BRACKET

20NR-119-1

| Entered:Date: | | | | ANDT | |
|---------------------------------------|------------------------------|--|---------------------------------------|------------------------|--|
| Description Wor | k Order Deviation | Disposition | | V' (| |

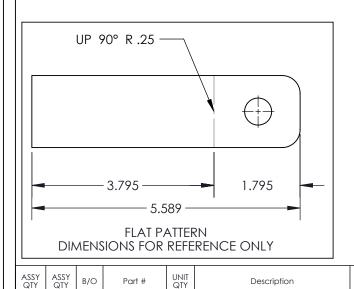
| Entered:Date: | | | | ANDT | |
|---------------------------------------|------------------------------|--|---------------------------------------|------------------------|--|
| DIMENSION 5.589 | ON FLAT PATTERN | -THIS DEVIATION IS A | ACCEPTABLE TO | Completed by | |
| CHANGED FOR 5.8 | | USE | | | |
| CHANGED FOR 3.0 | | | | Lead hand / Supervisor | |

| Entered:Date: | | | | ANDT | |
|---------------------------------------|------------------------------|--|---------------------------------------|------------------------|--|
| | | - FIT FORM AND FUI | | | |
| | | BE AS ORIGINALL | | | |
